## INVITATION FOR BIDS

CCK-2844.00-1-25

Princeton Greenhouse - Headhouse

ADDENDUM #1

**C2.0**

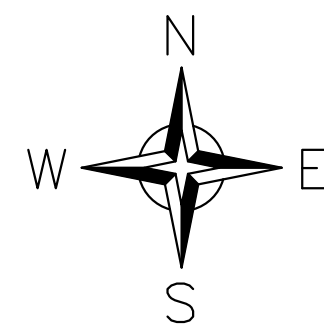
Refer to revised sheet C2.0 Site – Development Plan (Base Bid). Revised size and location of HVAC Unit concrete pad, and added pipe bollards to be installed at east corners of HVAC pad and all corners of Generator pad.

Refer to revised sheet C2.0 Site – Development Plan (Base Bid). Revised size of concrete pad outside of Mechanical Room and added bollards at proposed Gas Meter.

C3.0

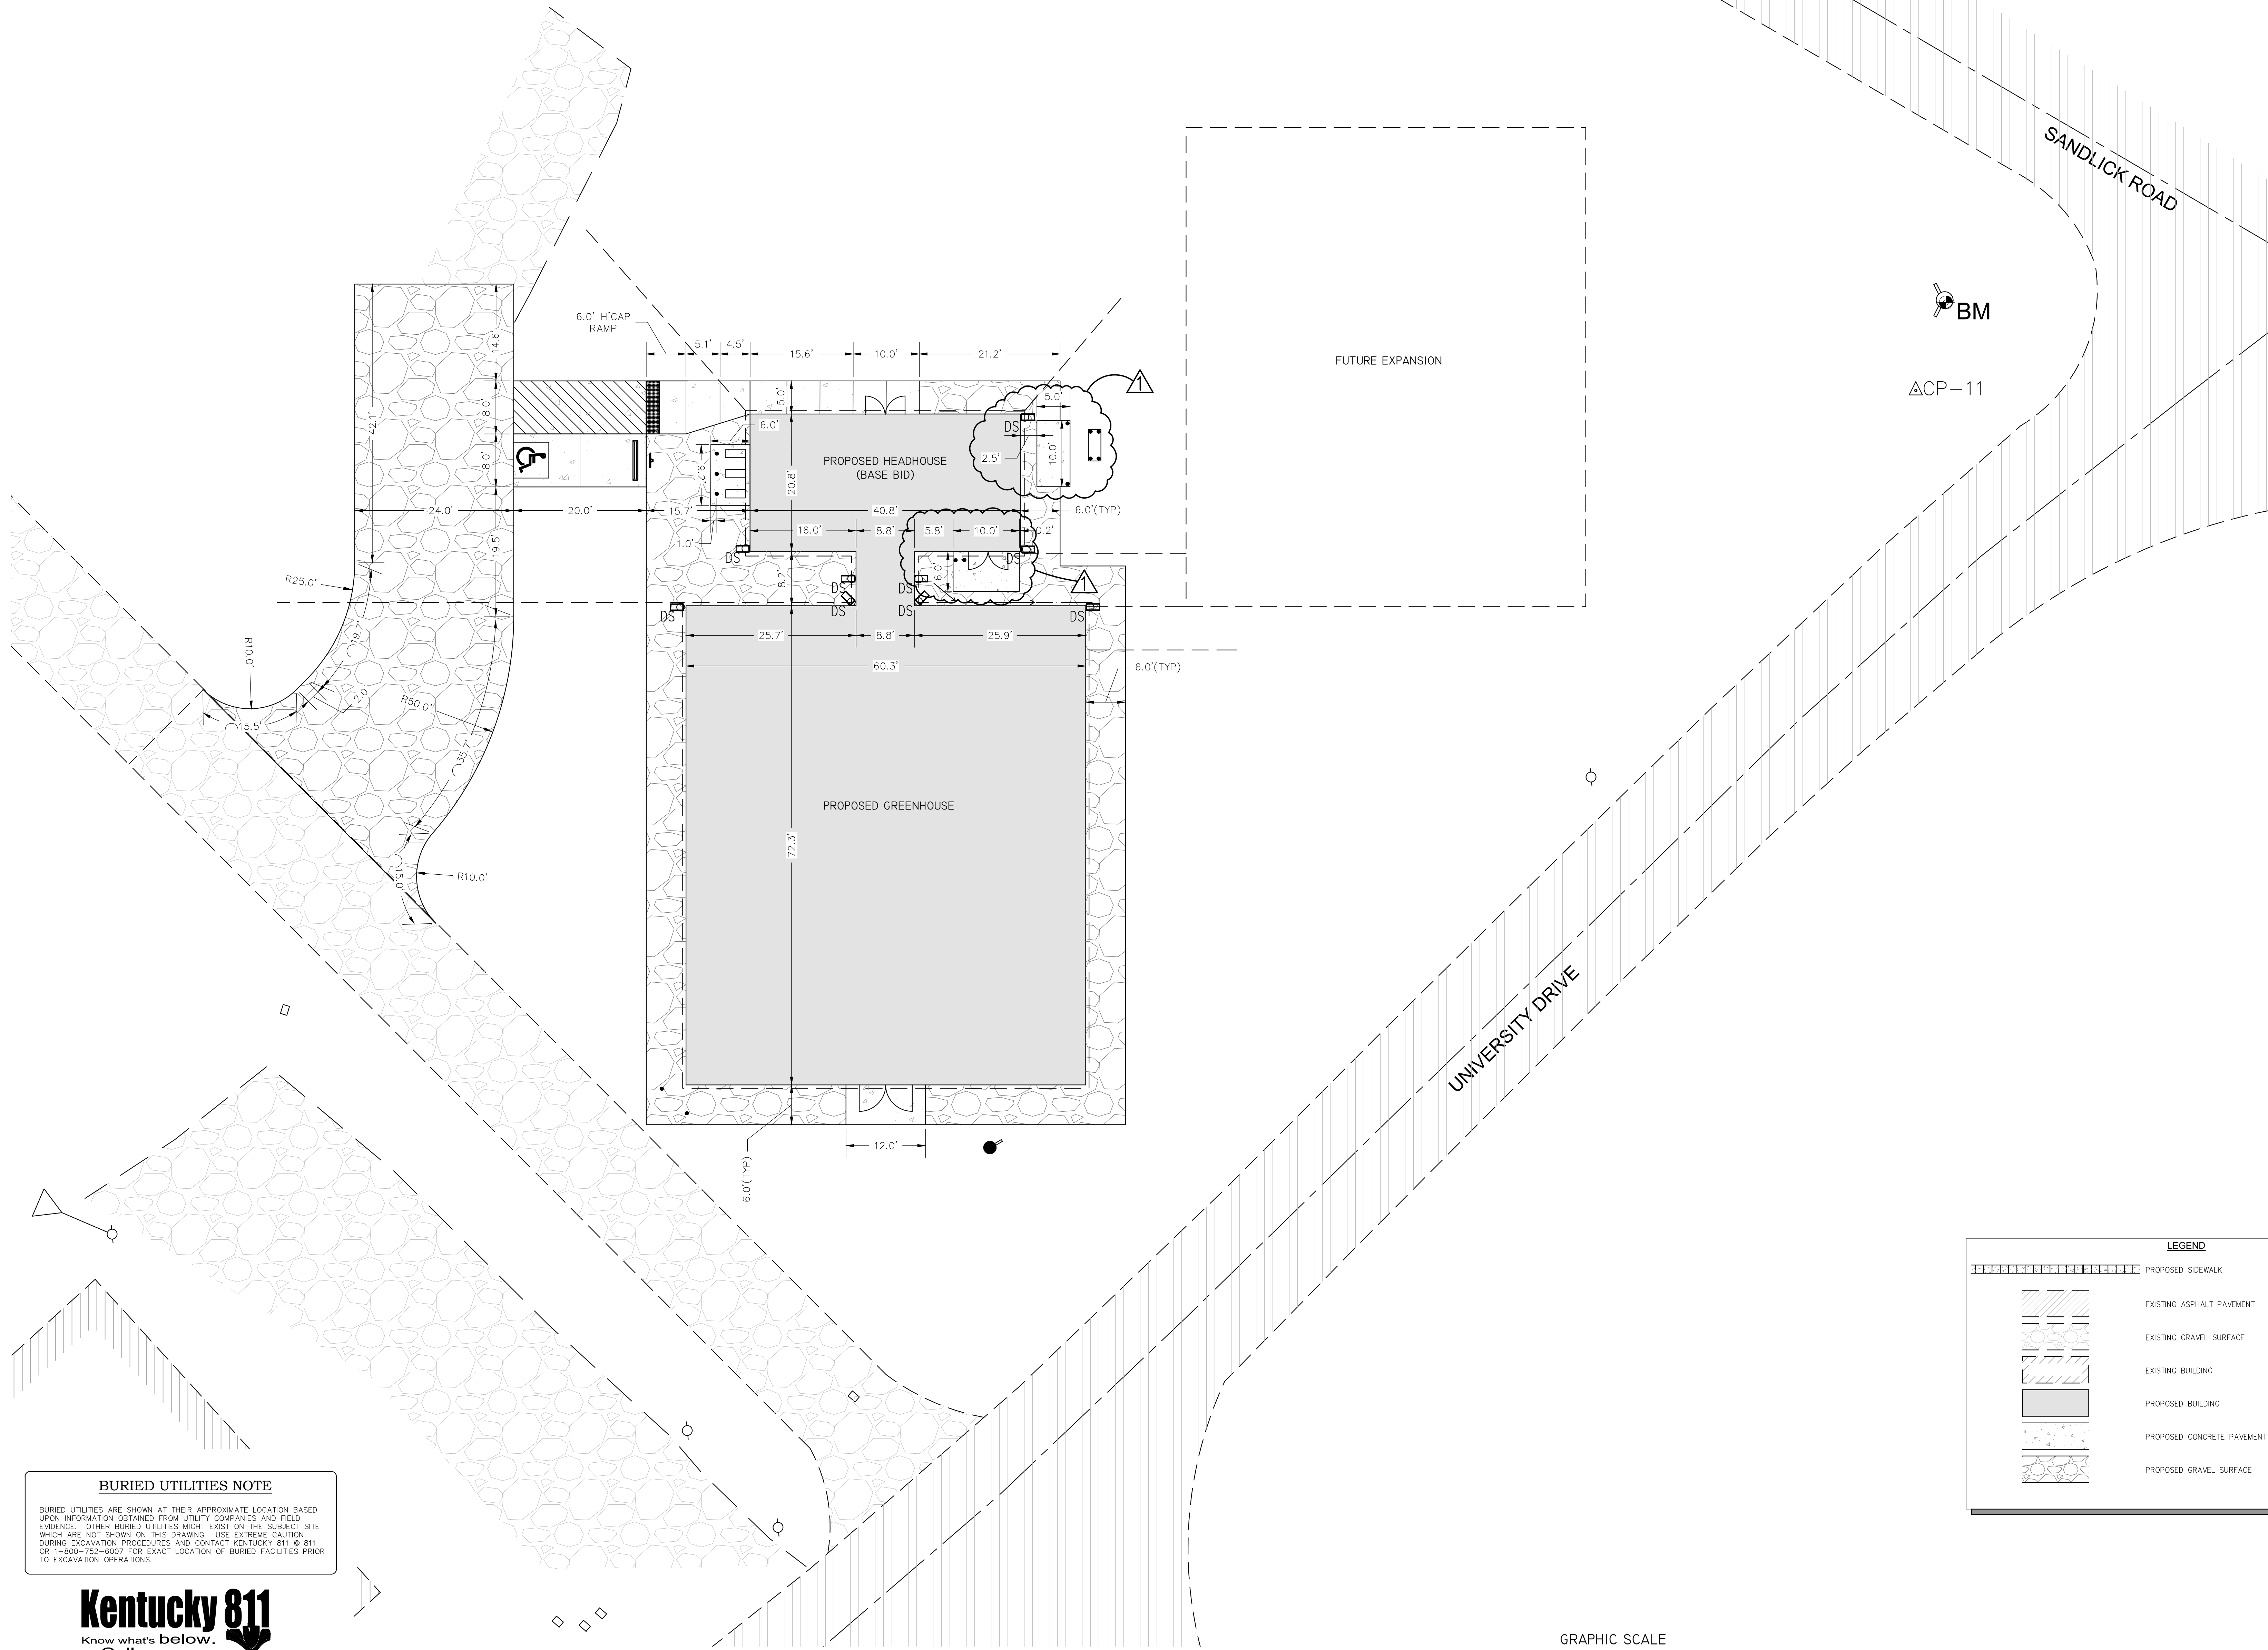
Refer to revised sheet C3.0 Site – Dimensional Plan (Base Bid). Revised dimensions and location of HVAC Unit concrete pad. Revised dimensions of concrete pad outside of Mechanical Room.

C6.0

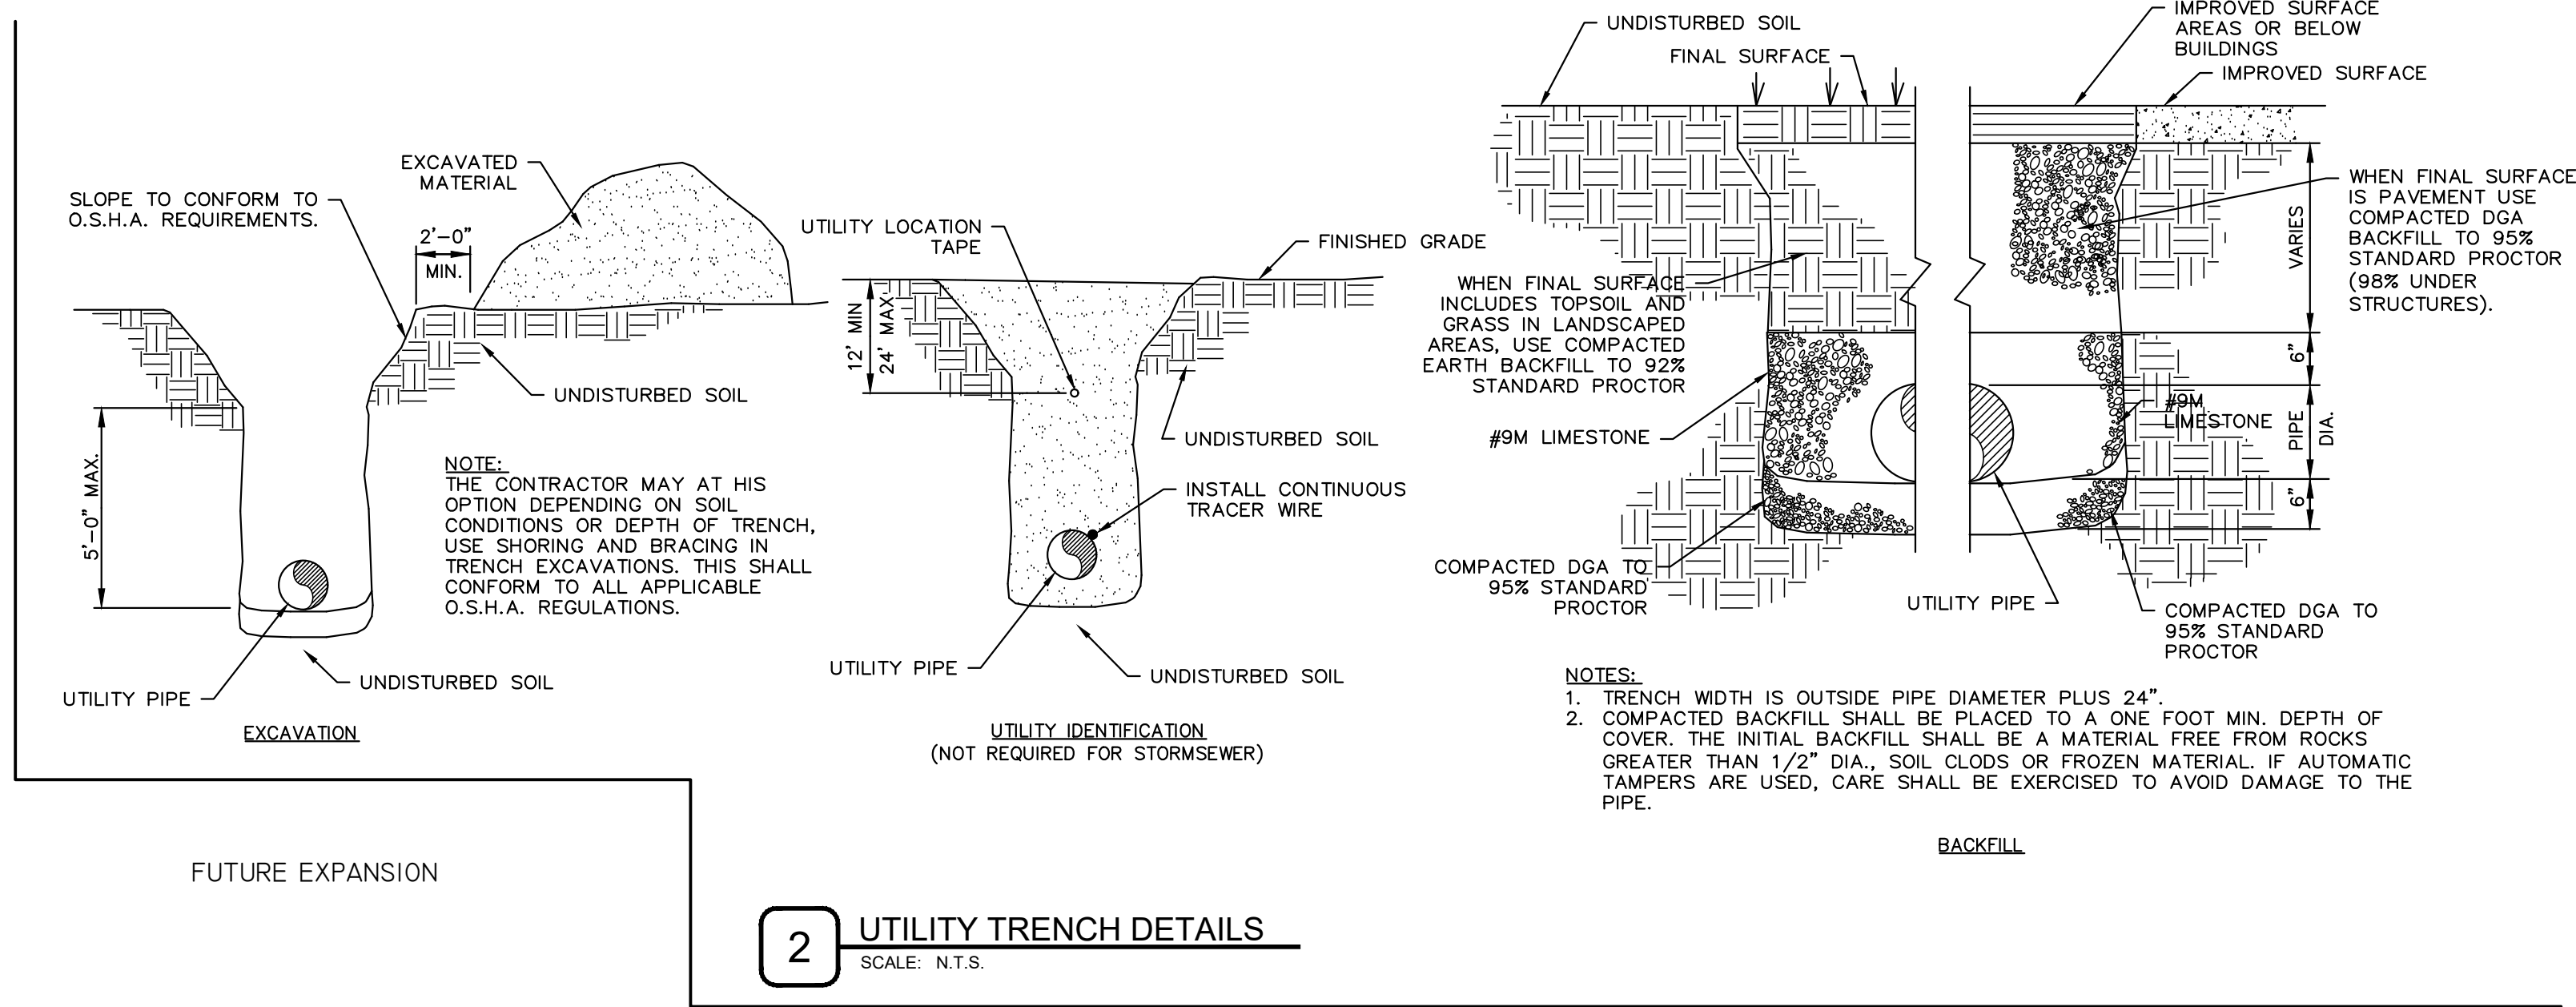
Refer to revised sheet C6.0 Site – Utility Plan. Revised size and location of HVAC Unit concrete pad, added pipe bollards to be installed at east corners of HVAC pad and all corners of Generator pad.

Refer to revised sheet C6.0 Site – Utility Plan. Add 2 pipe bollards at proposed Gas Meter.

A-102

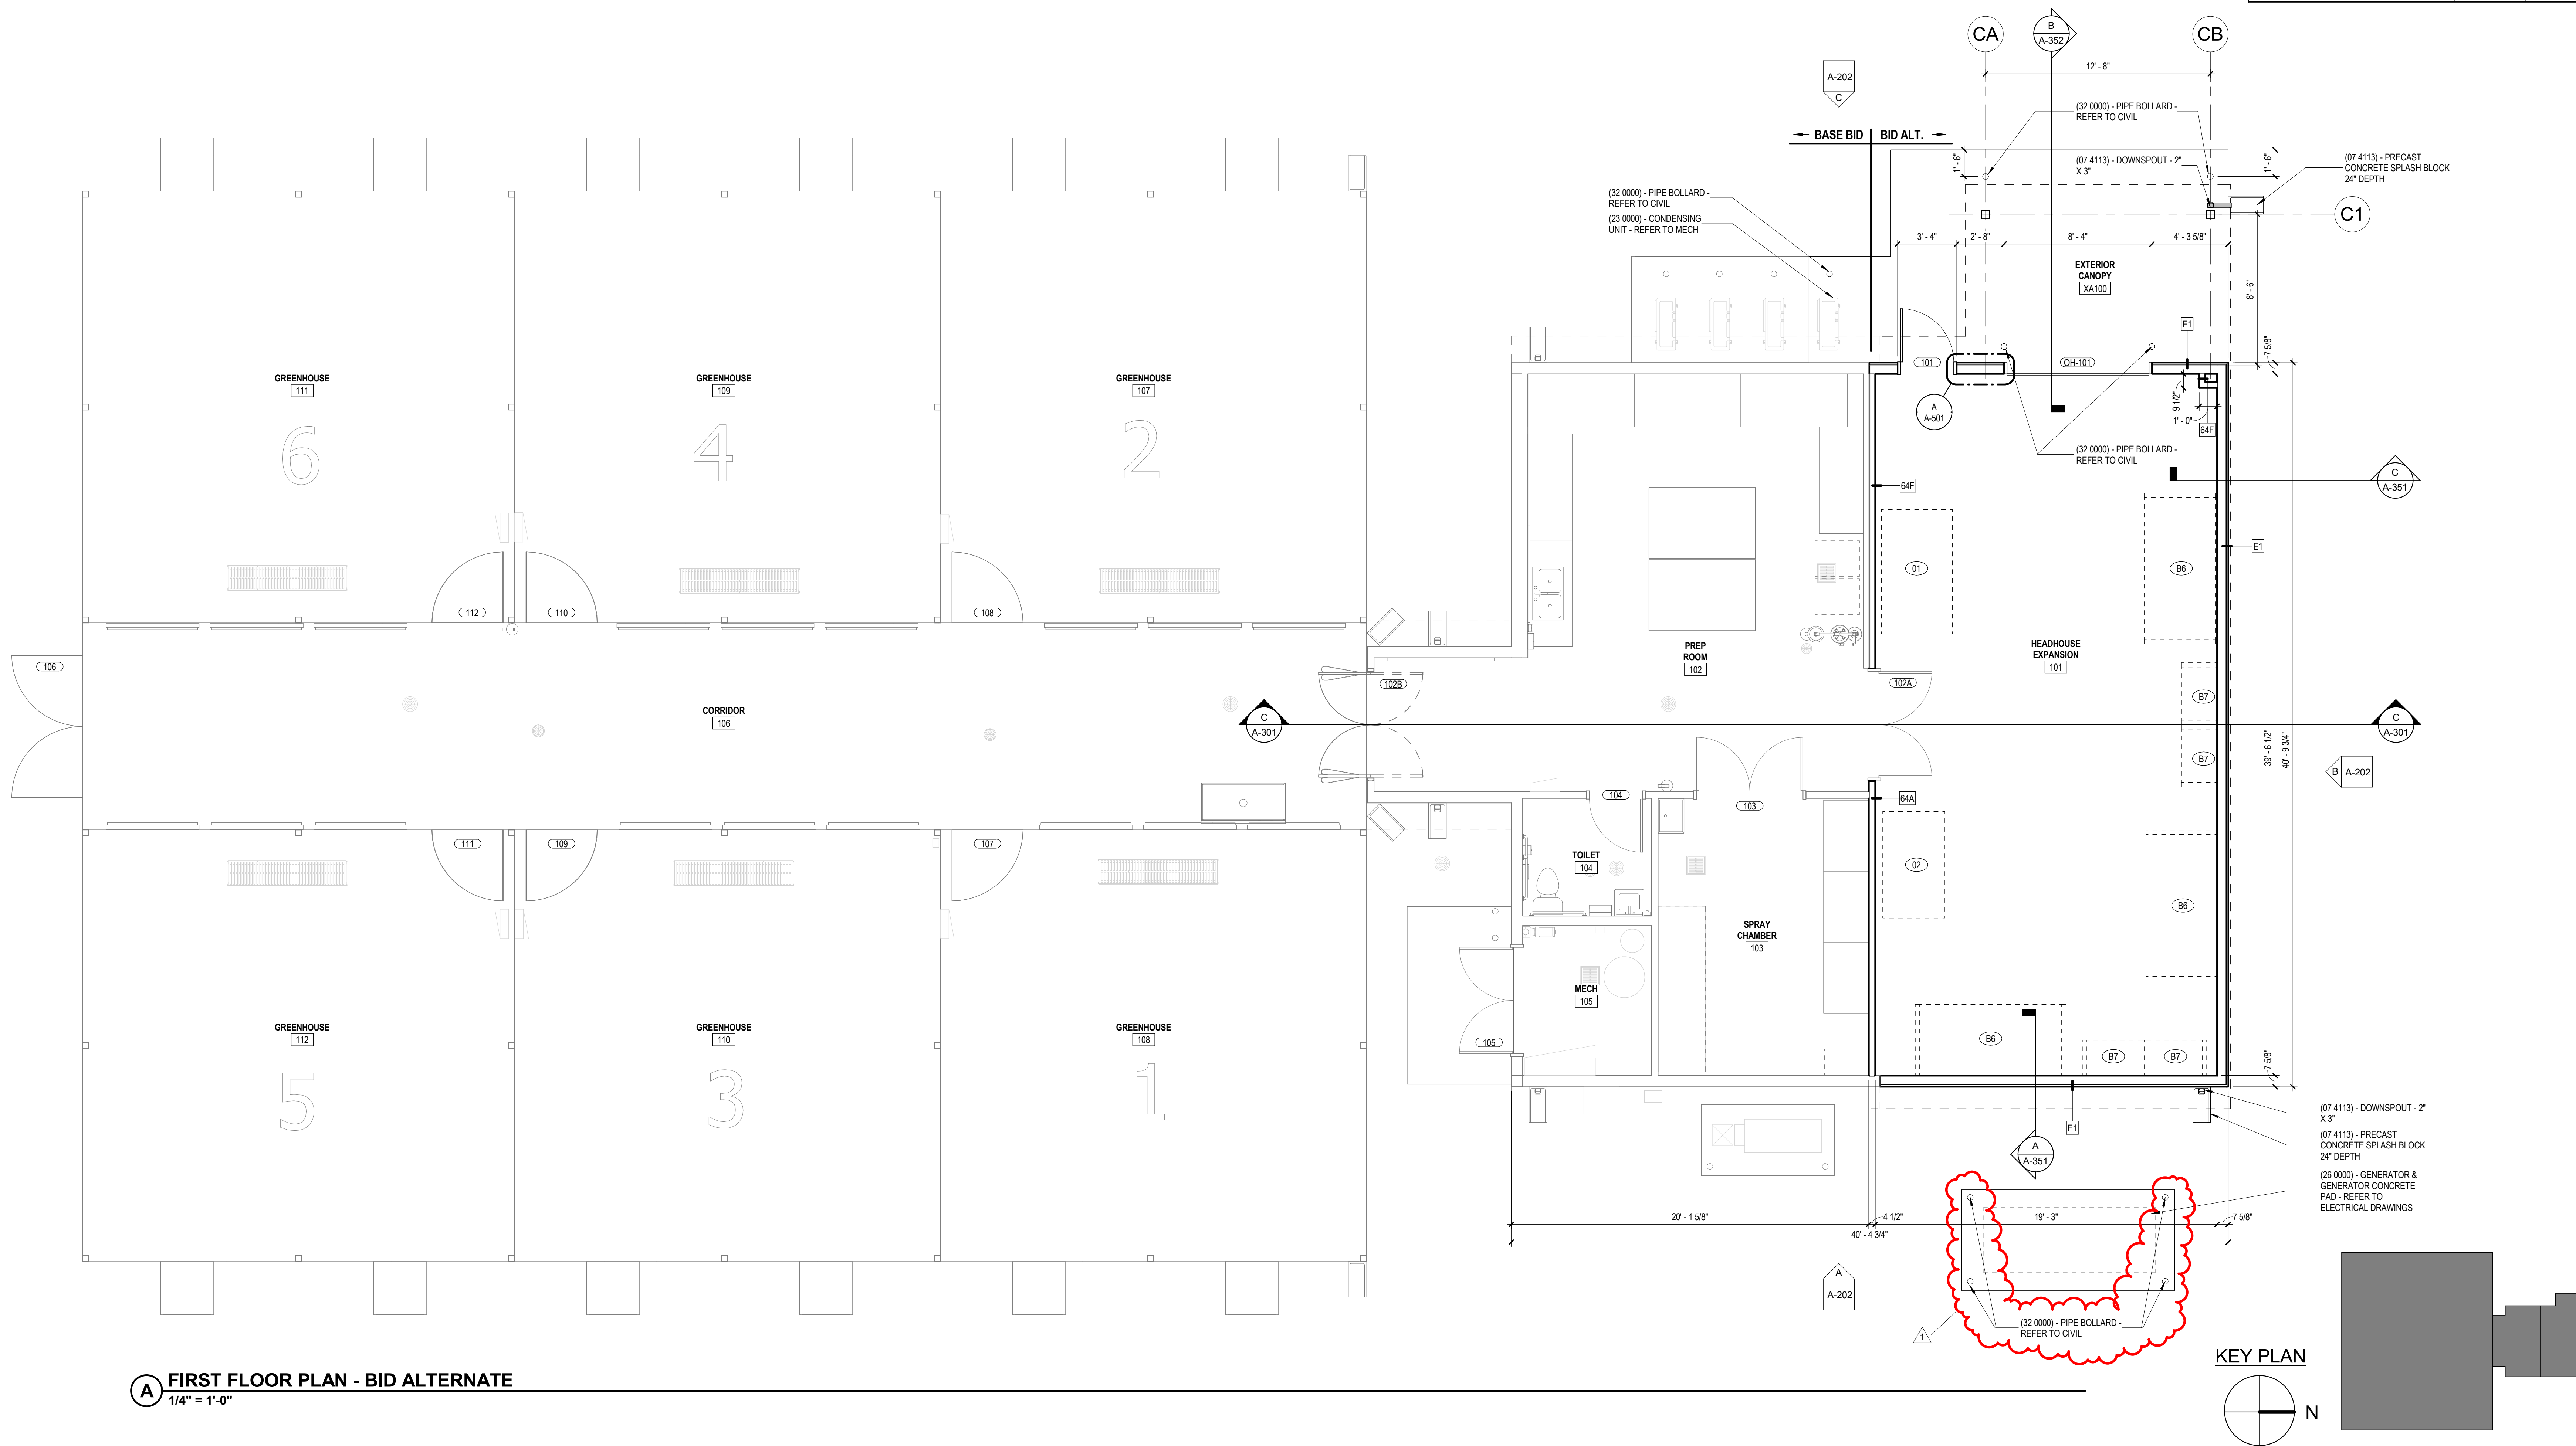
Refer to attached sheet A-101, A-102, A-201, A-202. Added bollards around HVAC unit, generator, and gas meter. Refer to civil & electrical for additional information.
